REQUEST FOR INFORMATION

RFI # **007**

RFI SUBJECT Drinking Fountain Drainage	CONTROL SECTION
JOB DESCRIPTION PW 7017 Puritan	JOB NUMBER PW 7017
CONTRACTOR Major Cement Co.	
LOCATION Purtian	DATE 04/14/21

GRADING PLAN

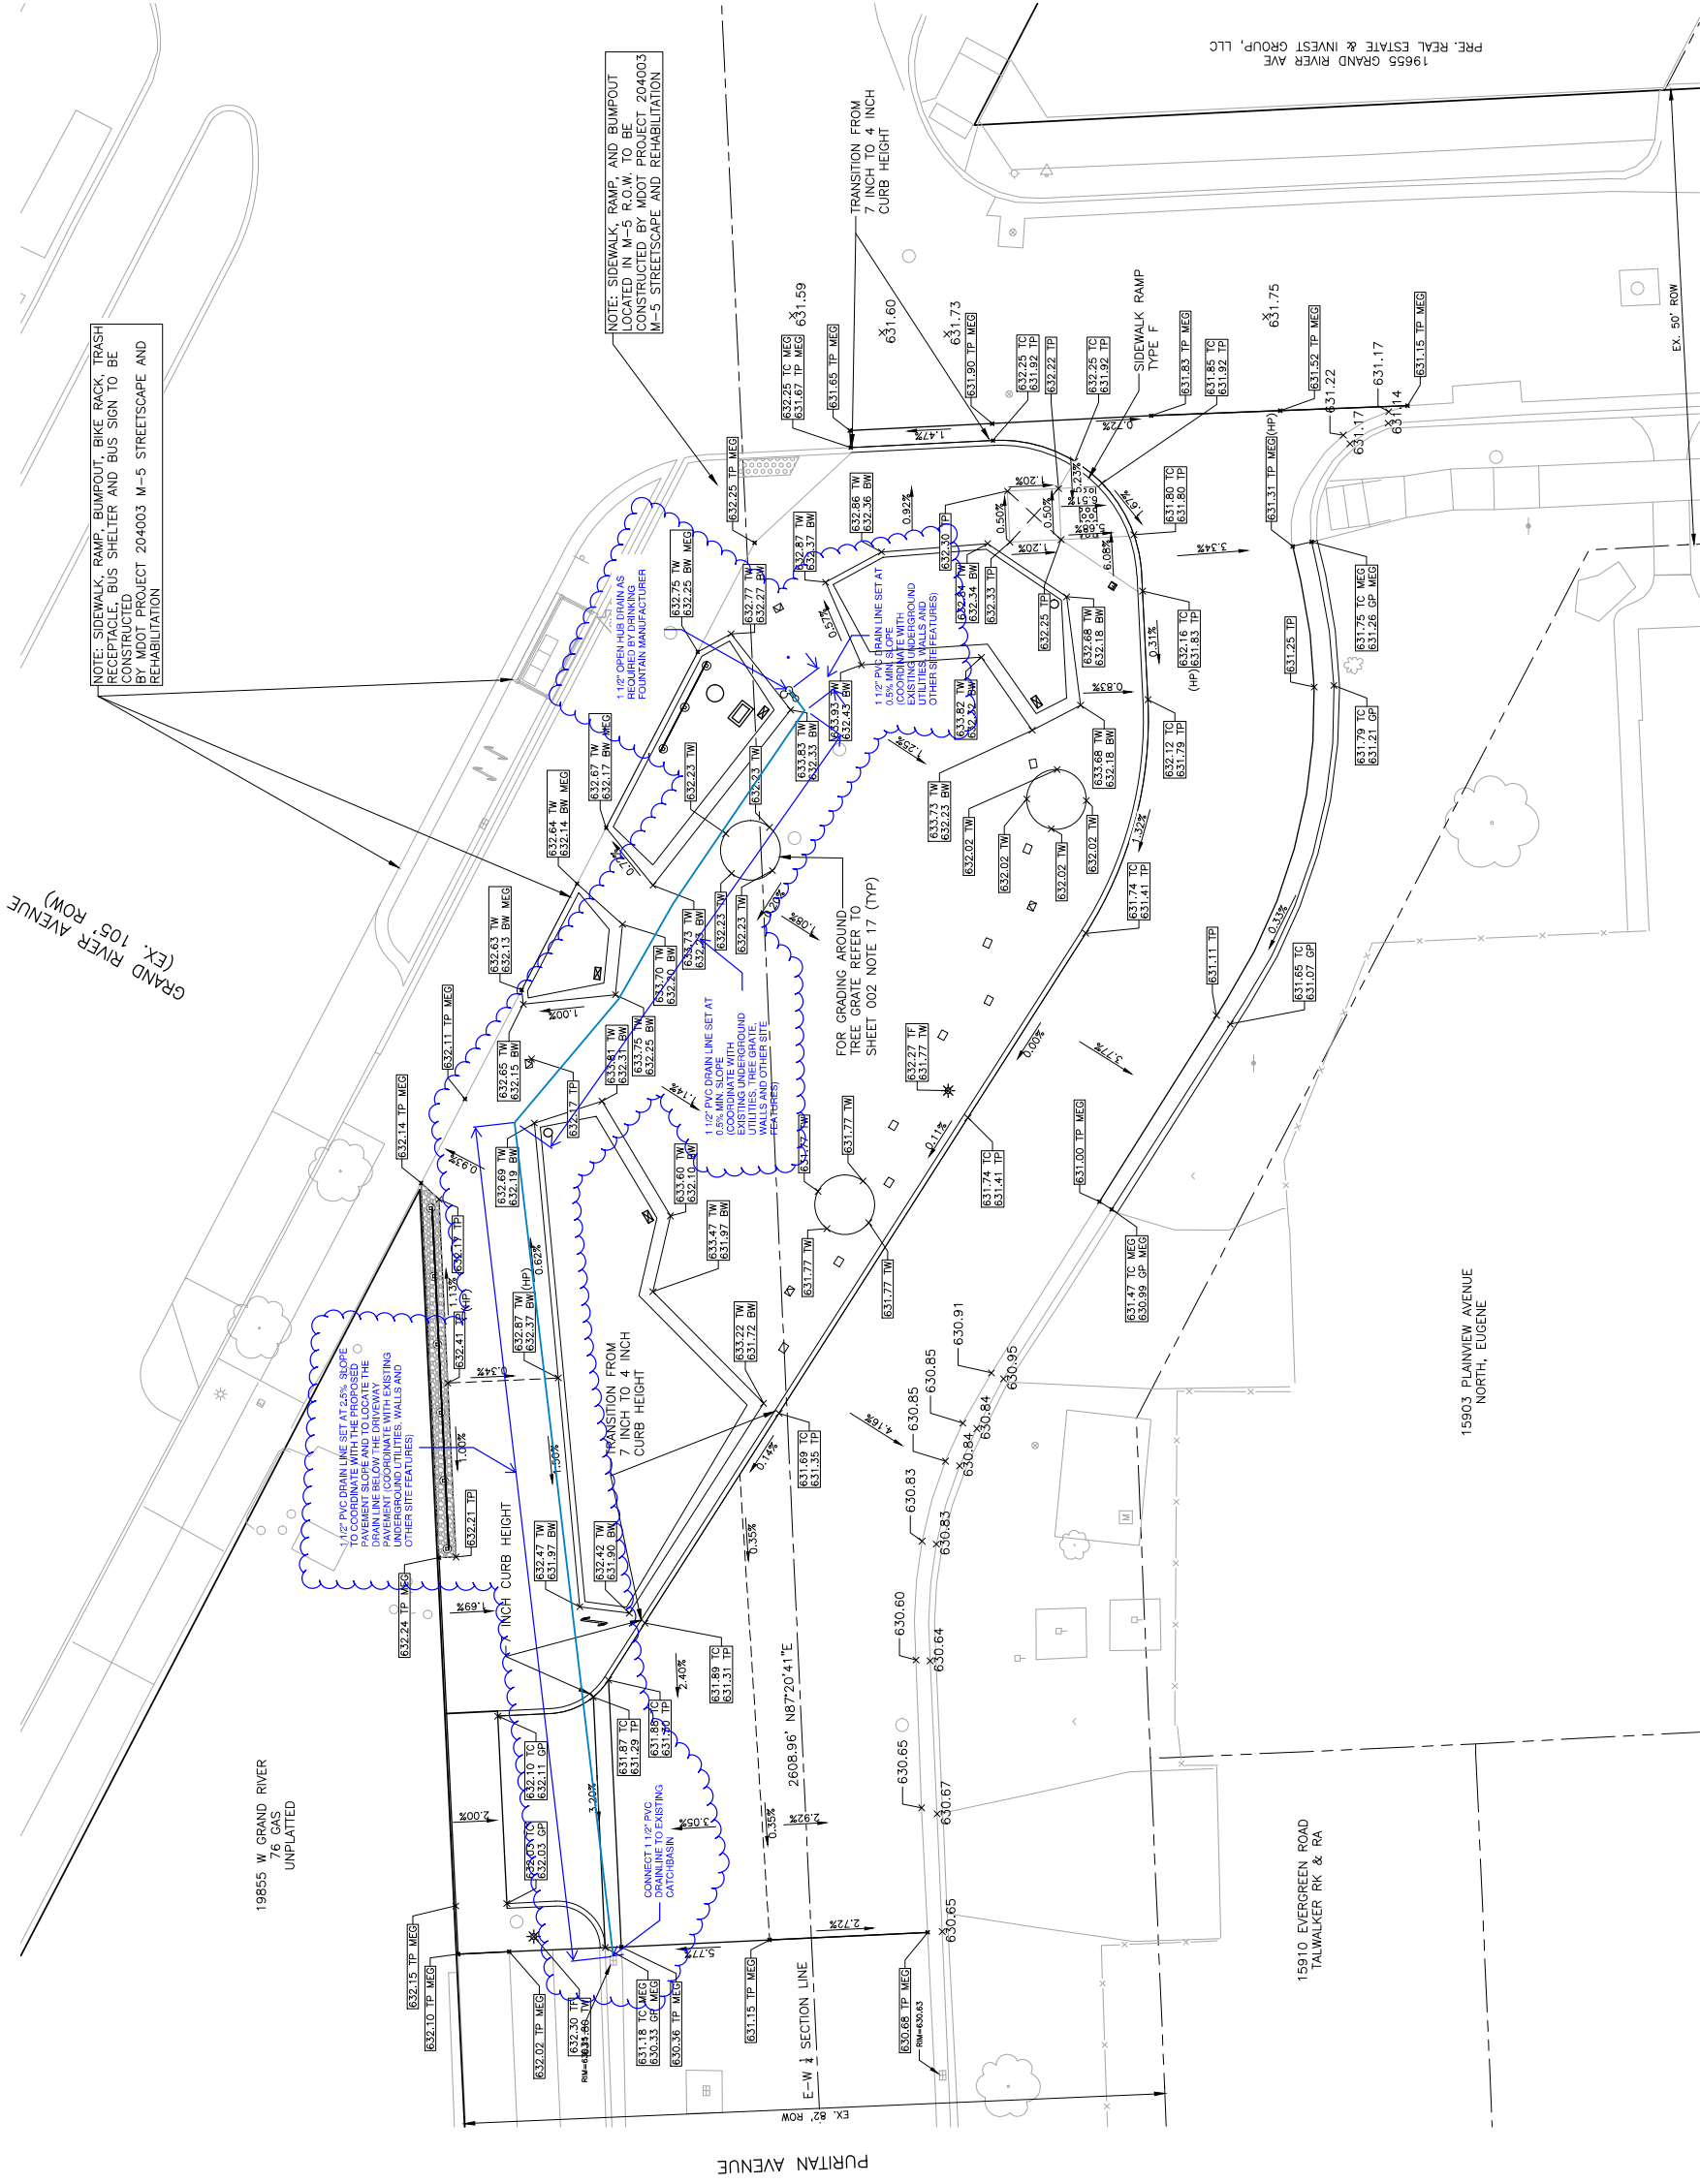
The project documents do not seem to be clear on drainage for the drinking fountain. Please confirm if drinking fountain drainage is required and if so, provide direction on where / how we should drain the fountain.

Provide a 1 1/2" Sch. 40 PVC drain line connection from the drinking fountain to the catch basin as shown on the enclosed PDF drawing and as noted on the drinking fountain submittal and construction details.
